Editor's ommision in ATA-3 (X3T13/D2008r7)

24 July 1996

It was pointed out at the June 19-21, 1996 ad hoc meetings that when I removed 8-bit data transfers from the ATA-3 document, I also inadvertently removed timing for 8-bit register reads and writes. It is proposed that the following clause be added to rectify this editorial mistake and return the required definition to the ATA-3 document.

Figure 14– Register transfer to/from device

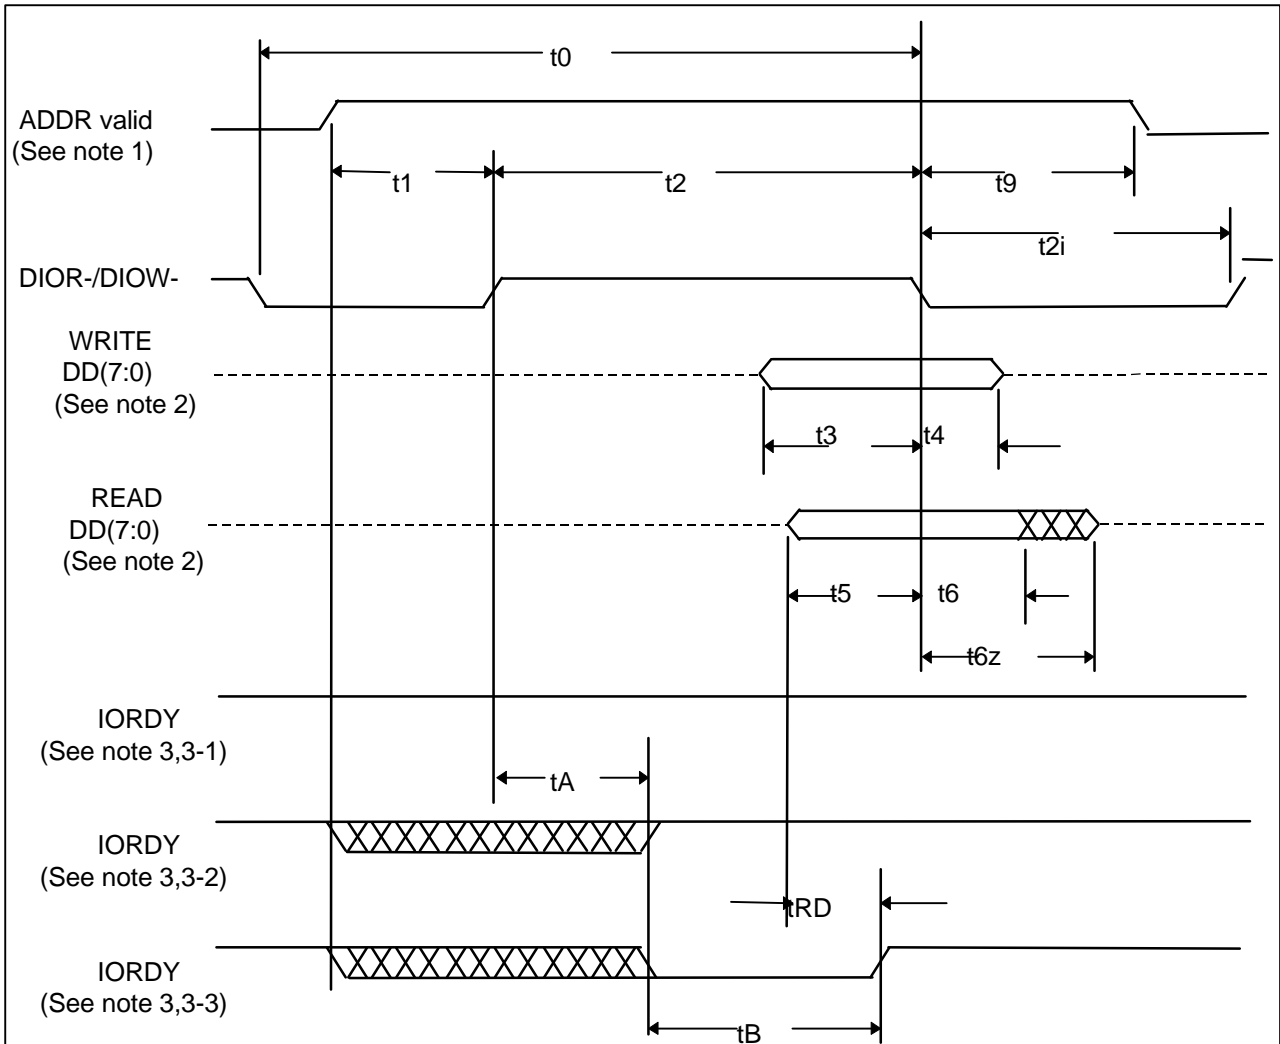
Figure 14 defines the relationships between the interface signals for 8-bit PIO register transfers. This timing applies to all register accesses except accesses to the Data register. Peripherals reporting support for PIO Transfer Mode 3 or 4 shall power up in a PIO Transfer Mode 0, 1 or 2.
